**TOWN OF NEWBURGH
PLANNING BOARD
TECHNICAL REVIEW COMMENTS**

PROJECT NAME: BANNERMAN VIEW SUBDIVISION
PROJECT NO.: 2013-17
PROJECT LOCATION: SECTION 22, BLOCK 4, LOT 6
REVIEW DATE: 30 APRIL 2015
MEETING DATE: 7 MAY 2015
REPRESENTATIVE: TALCOTT ENGINEERING

Re: CD Bannerman View Subdivision
Town Project No. 2013-17
S-B-L: 22-4-6
Job No. 13133-CDS

LOT LAYOUT
2 LOT SUBDIVISION ENTITLED:
CD BANNERMAN VIEW DRIVE SUBDIVISION
BANNERMAN VIEW DRIVE (S/B/L: 22-4-6)
TOWN OF NEWBURGH, ORANGE COUNTY, NEW YORK

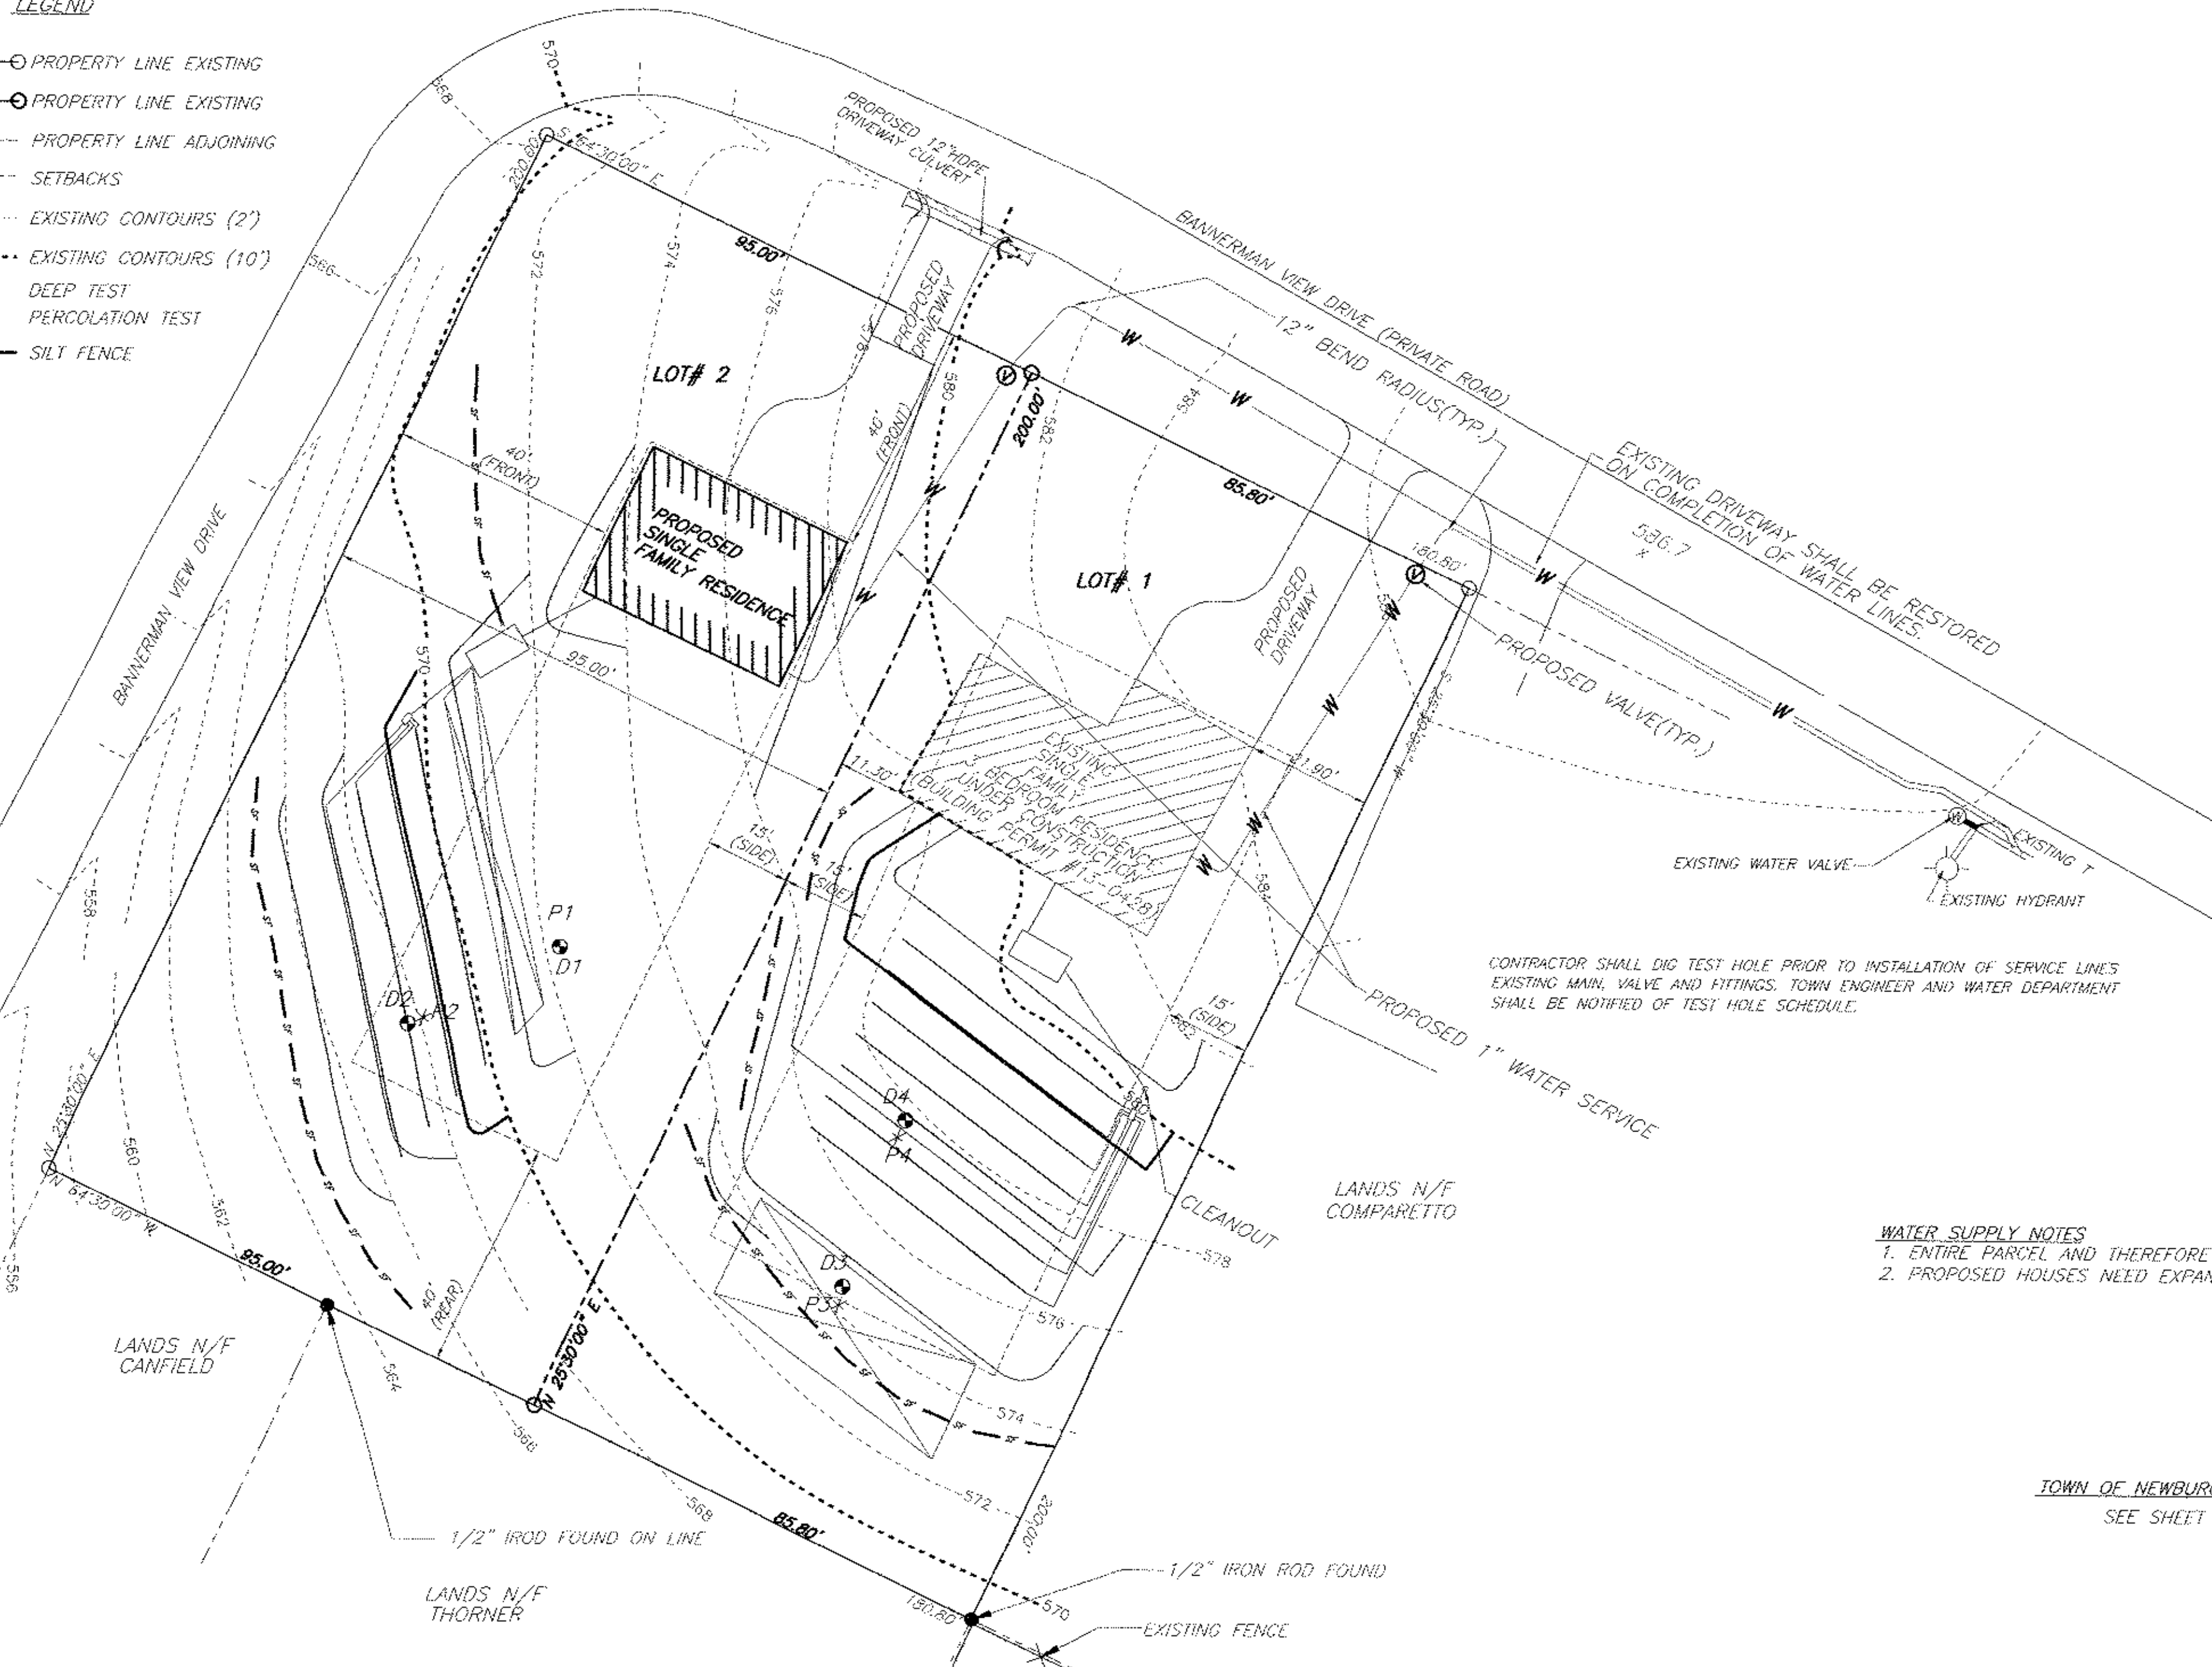
1. The Applicant's Representative has resolved the water line issue with the Town of Newburgh. Town is permitting the installation of 2 separate water service laterals to serve the proposed lots. This was the last outstanding technical issue on the project. Status of the project's Public Hearing should be addressed. If required, Public Hearing could be scheduled.

1. The required variances were granted on April 23, 2015.
2. The water main taps are now shown as two individual 1" service line, with no extension of the existing water main, as per John Platt of the Town water Department.
